VOLLMER RV STORAGE

GRADING AND EROSION CONTROL PLAN

PCD File No. PPR-22-045

Grading and Erosion Control Plan_V1.pdf Markup Summary

VOLLMER RV STORAGE
EROSION CONTROL PLAN

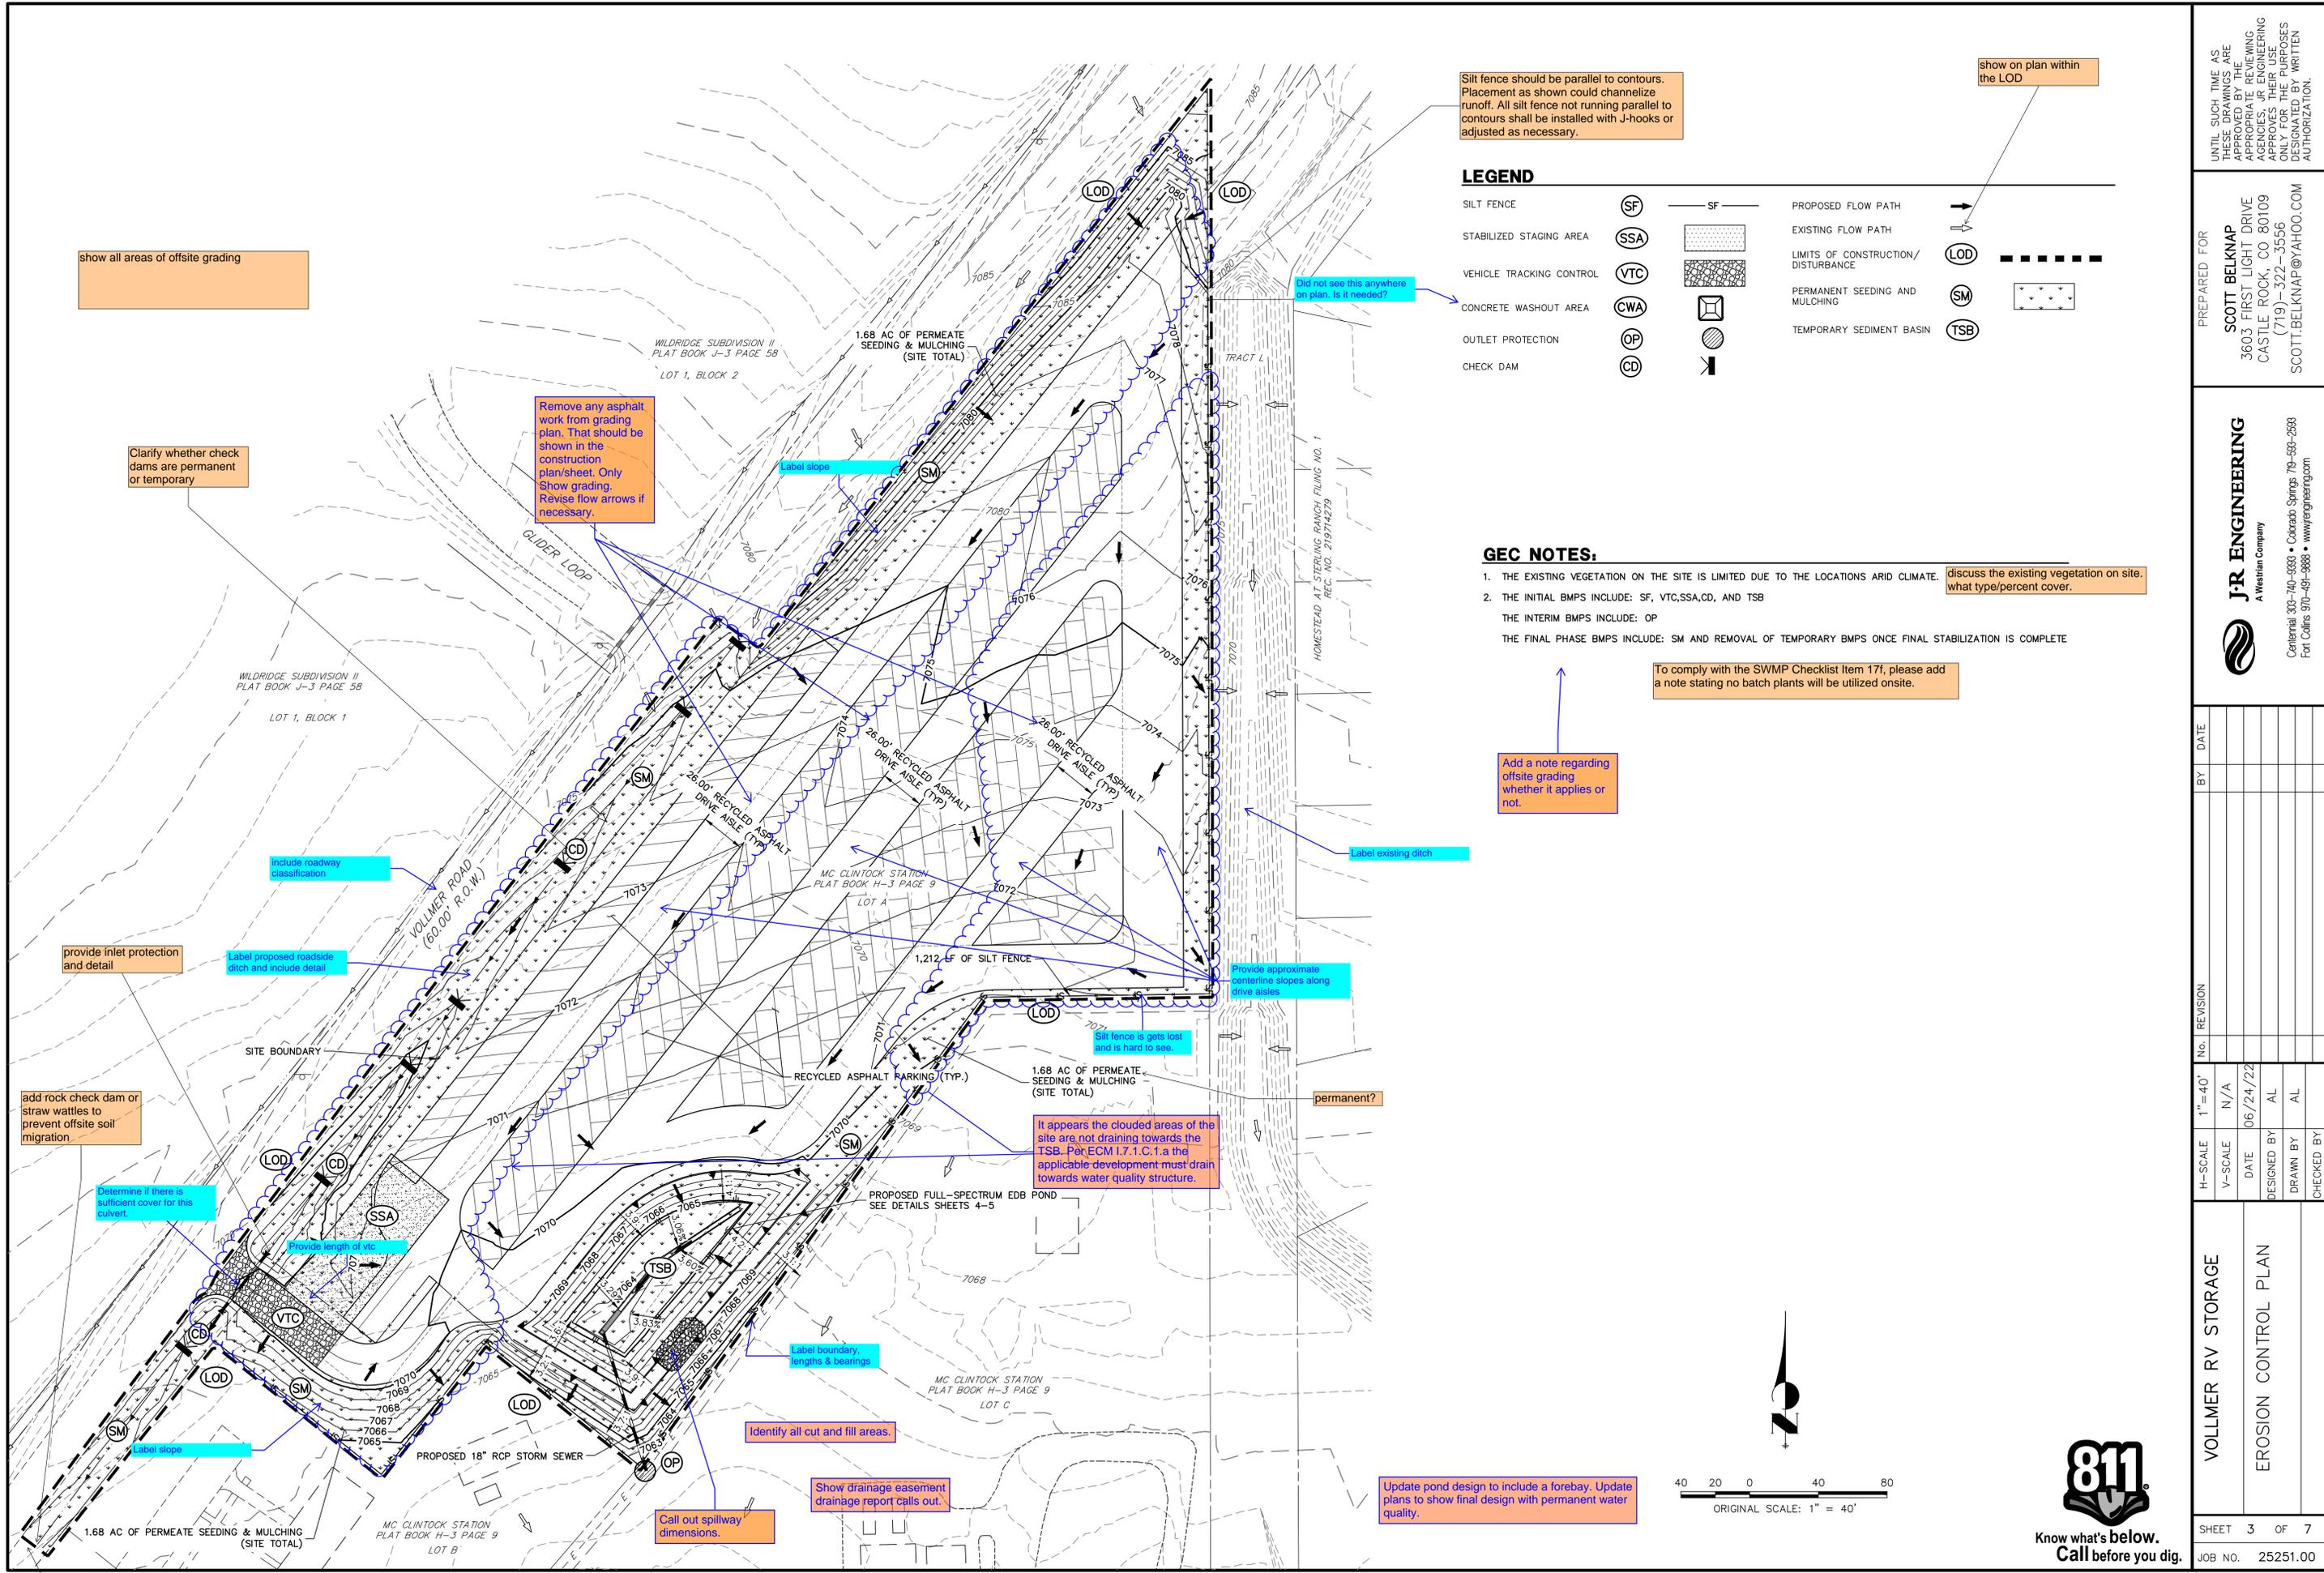
Silt fence should be parallel to contours. Placement as shown could channelize runoff. All silt fence not running parallel to contours shall be installed with J-hooks or adjusted as necessary.

show on plan within the LOD

- THE EXISTING VEGETATION ON THE SITE IS LIMITED DUE TO THE LOCATIONS ARID CLIMATE. discuss the existing vegetation on site, what type/percent cover.
- THE INITIAL BMPs INCLUDE: SF, VTC, SSA, CD, AND TSB
THE INTERIM BMPs INCLUDE: OP
THE FINAL PHASE BMPs INCLUDE: SM AND REMOVAL OF TEMPORARY BMPs ONCE FINAL STABILIZATION IS COMPLETE

To comply with the SWMP Checklist Item 17f, please add a note stating no batch plants will be utilized onsite.

Add a note regarding offsite grading whether it applies or not.

show all areas of offsite grading

Remove any asphalt work from grading plan. That should be shown in the construction plan/sheet. Only show grading. Revise flow arrows if necessary.

Clarify whether check dams are permanent or temporary

Did not see this anywhere on plan. Is it needed?

include roadway classification

provide inlet protection and detail

Label proposed roadside ditch and include detail

add rock check dam or straw wattles to prevent offsite soil migration

Determine if there is sufficient cover for this culvert

Provide length of vic

It appears the clouded areas of the site are not draining towards the TSB. Per ECM 1.7.1.C.1.a the applicable development must drain towards water quality structure.

Provide approximate centerline slopes along drive aisles

Silt fence is gets lost and is hard to see.

permanent?

Identify all cut and fill areas.

Show drainage easement drainage report calls out.

Call out spillway dimensions.

Update pond design to include a forebay. Update plans to show final design with permanent water quality.

is this tying into an existing roadside ditch?

GEC DETAILS

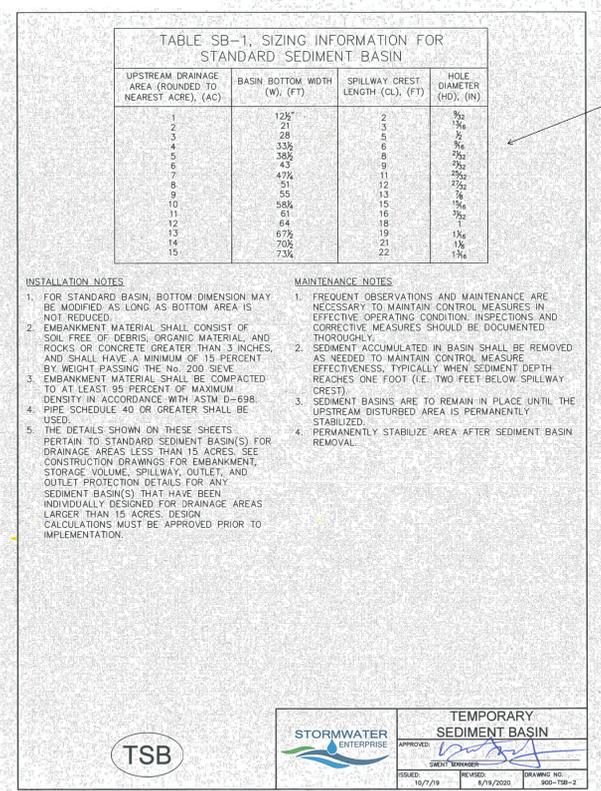
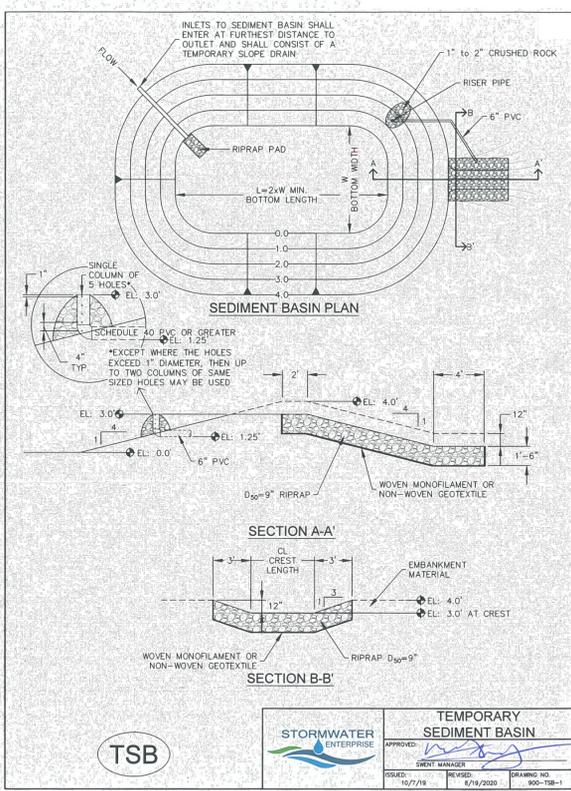
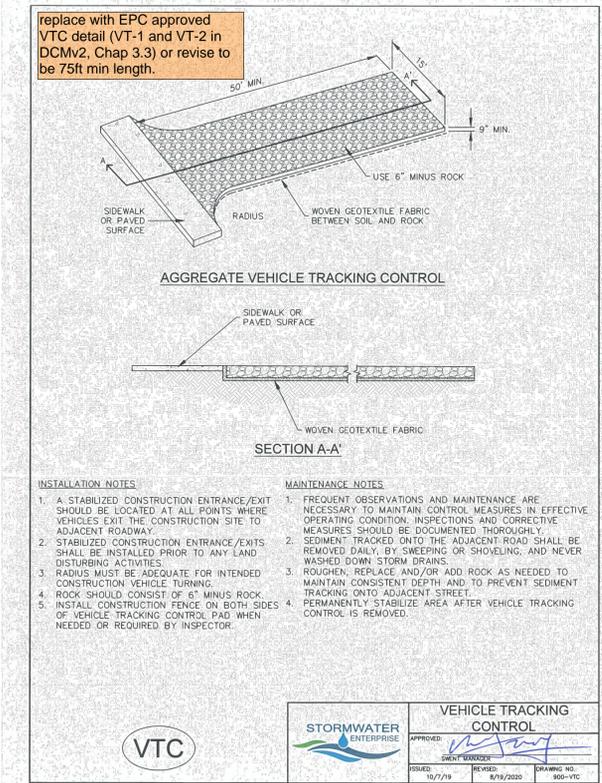
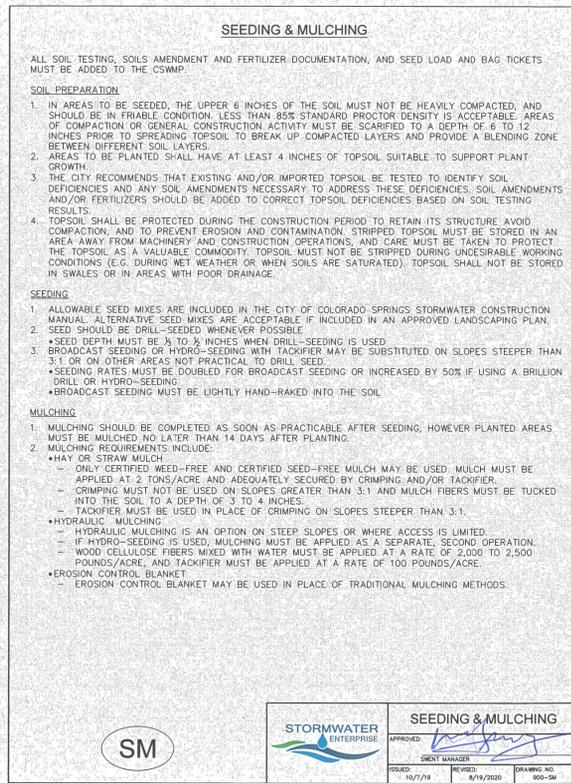
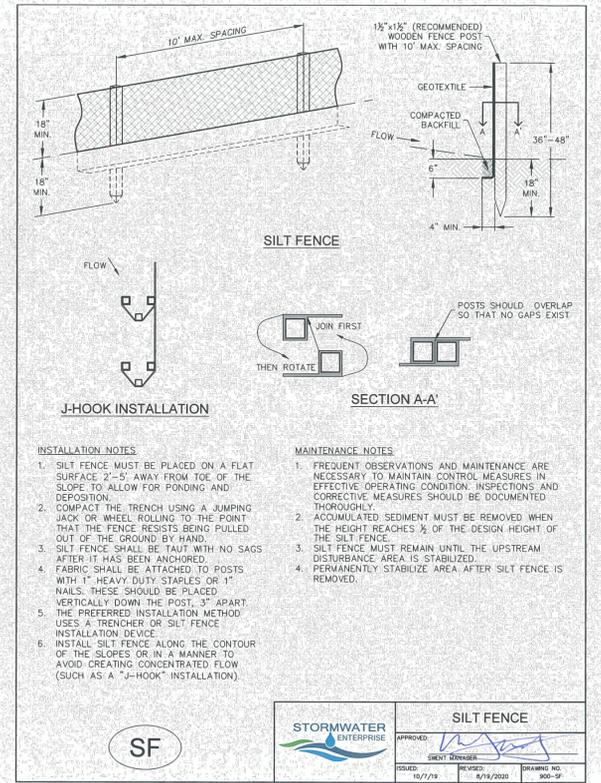
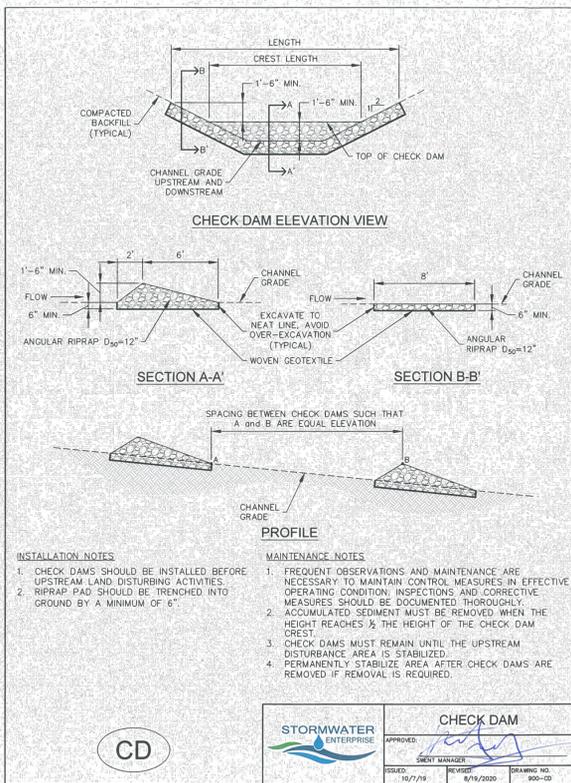
call out which sizing applies

include concrete washout detail and inlet protection detail
